21-157ARB-INF – 143 S. RIVERVIEW ST. – LYON RESIDENCE

Demolition of an existing single-family home and construction of a new one-and-a-half story, single-family home on a 0.21-acre site in Historic Dublin.

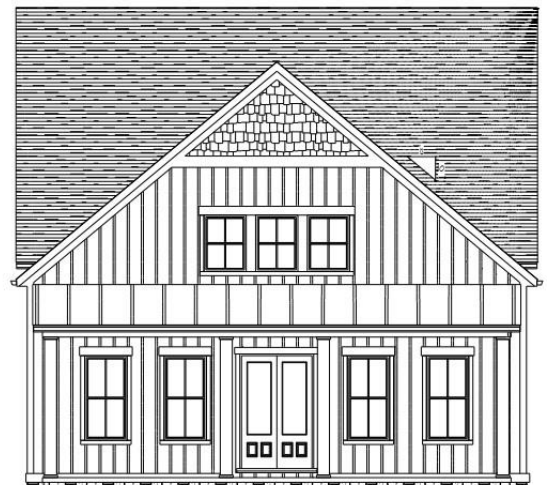
The applicant is proposing to construct a new residential structure, while keeping the existing, detached garage. The proposed structure is shown as meeting the minimum 3-foot side yard setback requirement from the south property line, and is set back significantly further than 9 feet from the north property line, meeting the minimum 12-foot side yard setback sum required. The rear yard setback of 20% of lot depth is 33 feet, and is amply met. The front yard setback is required to be 20 feet; only 14 feet 3 inches is shown in this location. Front yard setback requirements will need to be met with any formal application.

Lot coverage is stated at 37 percent, where a maximum of 45 percent is required per Code. With a formal Minor Project Review, this should be shown as a table on the site plan including all impervious and semi-impervious surfaces for the total percentage.

It appears that the existing driveway is partially on the adjacent property to the north. It may benefit the property owner to obtain a driveway easement, if not already existing; however, since the driveway is not being relocated, this is not required for this review nor any future Minor Project Review.

North/Side Elevation

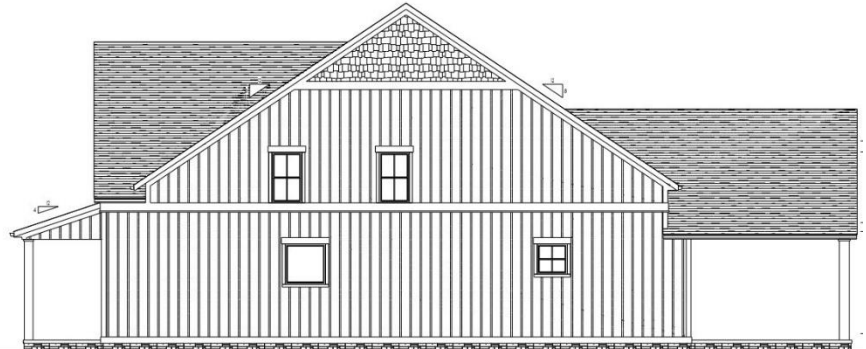
The north elevation contains the main cross gable of the house (12-over-8 pitch), with both front and rear covered porches visible. The rear porch has a perpendicular gable with asphalt shingles and is approximately 700 square feet in size. Board-and-batten siding is shown again, with vinyl shake shingles proposed for the gable top detail. Four windows are arranged on this elevation, three of which are two-over-two, and one of which is a single light. No other fenestration or articulation is proposed along this elevation.

The proposed height of the building is shown at 34 feet to the peak of the main gable. Per Code, the City measures height to the mid-point of the gable, with a maximum permitted height of 24 feet in this zone district. Compliance with this criterion and compatibility with surrounding homes and context will need to be demonstrated, should the application move forward.

South/Side Elevation

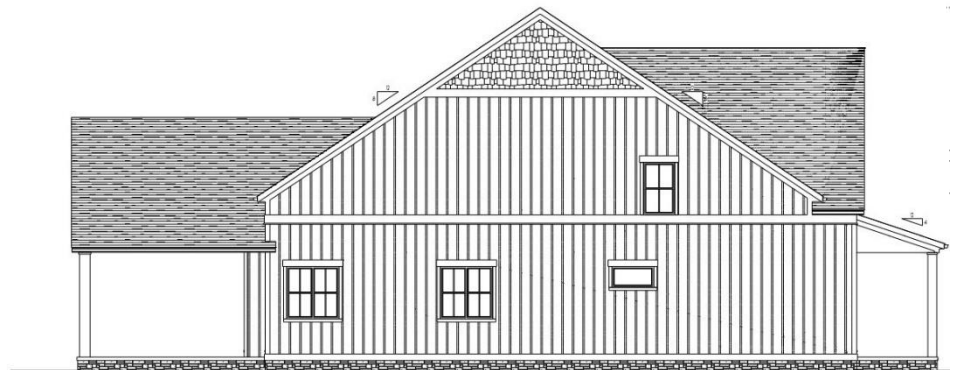
The south elevation is similar to the north elevation, with the main cross gable strongly present, both covered porches visible, primarily board-and-batten siding, and vinyl shake shingle detail in the upper gable. The roof pitch is 12-over-8.

Four window groupings are randomly arranged: two double two-over-two windows are located on the first floor, one single-light window is also on the first floor, and one two-over-two window is shown on the upper floor. This elevation has a proposed 3-foot setback; there may

be Building Code implications on windows that close to the property line. The foundation material is not identified. No other fenestration or articulation is proposed on this elevation.

West/Rear Elevation

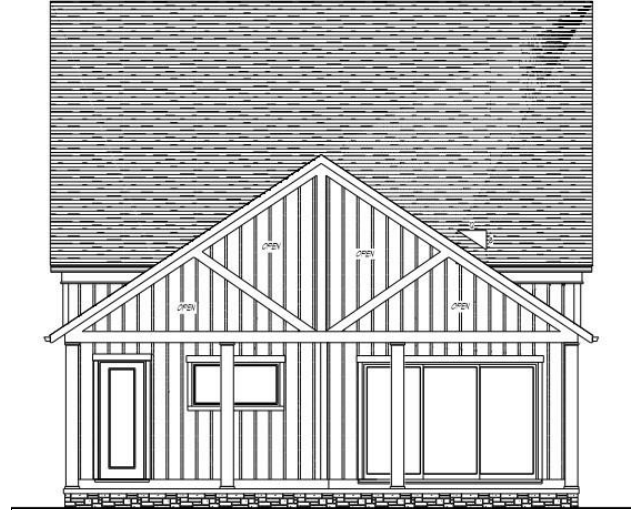
The west elevation shows an open-gabled porch (12-over-8 pitch) with triangular braces for the roof structure. The board-and-batten siding is visible through the roof structure. Four columns support the roof. A single-pane access door is shown, along with a single-pane window adjacent. Sliding glass doors are also shown on this elevation.
